**CITY OF LA VISTA**  
**MAYOR AND CITY COUNCIL REPORT**  
**NOVEMBER 6, 2018 AGENDA**

<b>Subject:</b>	<b>Type:</b>	<b>Submitted By:</b>
CHANGE ORDER NO 7 84 <sup>TH</sup> STREET REDEVELOPMENT AREA PUBLIC IMPROVEMENT REDEV. PROJECT OFFSTREET PKG. DIST. NO. 2 – STRUCTURE No. 1	◆ RESOLUTION ORDINANCE RECEIVE/FILE	JOHN KOTTMANN CITY ENGINEER

**AIA® Document G701™ – 2017**
**Change Order**

## Change Proposal Request

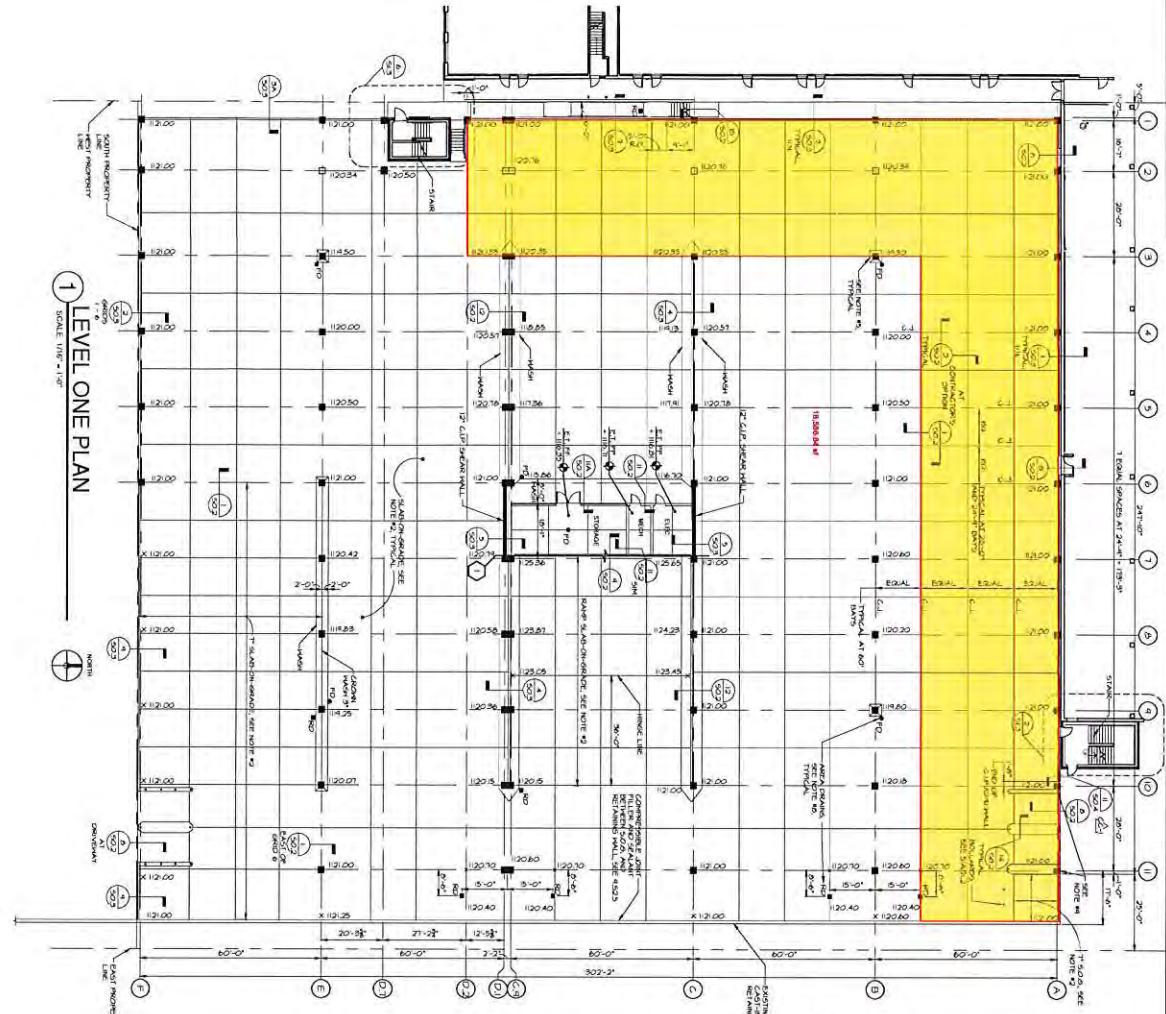
Description of Change: Pour 18,587 SF of Slab 7" Thick in lieu of 5" Thick
